Application No.: 10/703,390
Applicant: van den Brink et al.
Docket No.: 903-91 PCT/US/CIP
Page 8

Amendments to the Drawings:

Remarks/Arguments:

A SYSTEM FOR PERFORMING EXPERIMENTS, IN PARTICULAR FOR HIGH THROUGHPUT EXPERIMENTATION

Fig 2

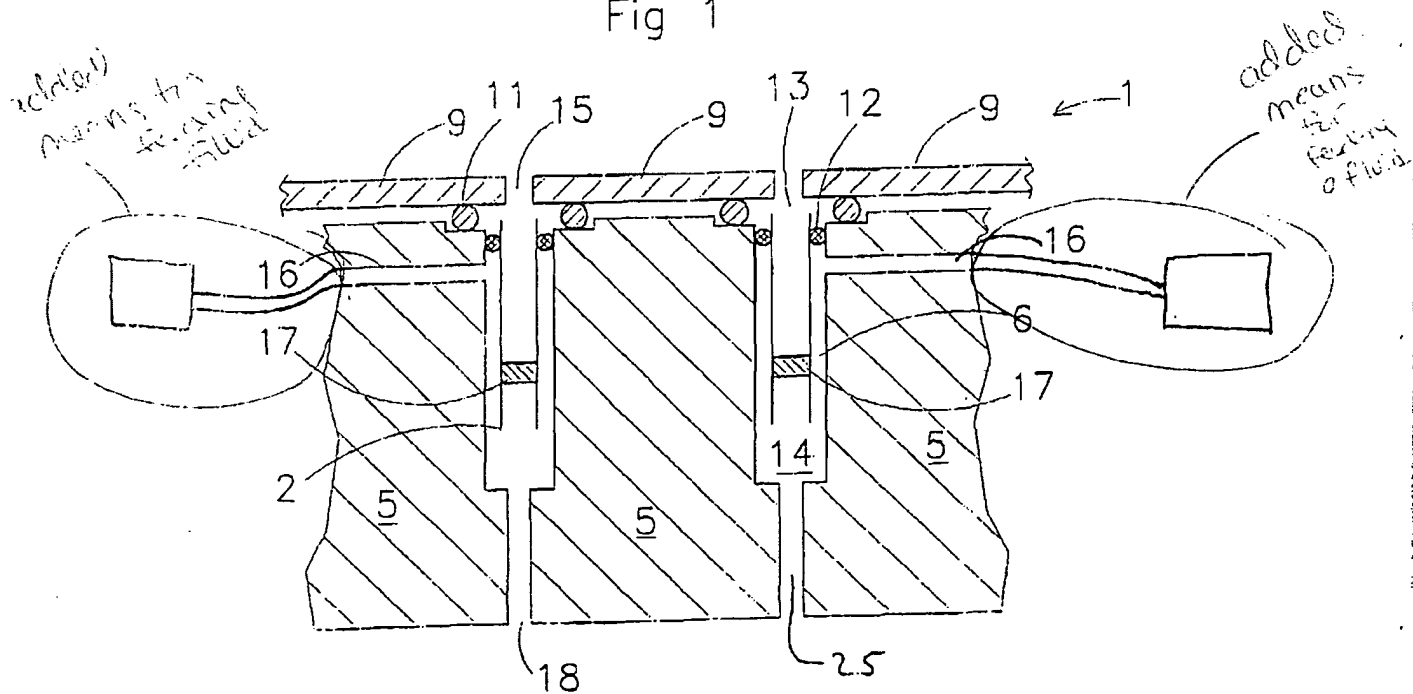
The Figures 2 and 3 on attached replacement sheets 1/3 and 2/3 have been changed. In Figure 2 previously omitted means for feeding fluid has been added. In Figure 3 previously omitted means for feeding fluid has been added. No new matter is introduced with these amendments.

The drawings were objected to 35 under 37 CFR 1.83(a) as allegedly not showing the means for feeding a fluid via the fourth channel. The means for feeding fluid via the fourth channel is described in the specification at par.[0031], [0063] – [0065]. The means for feeding fluid via the fourth channel 16 has been added to Figures 2 and 3 of Replacement Sheet 1/3 and 2/3. No new matter is introduced with these amendments.
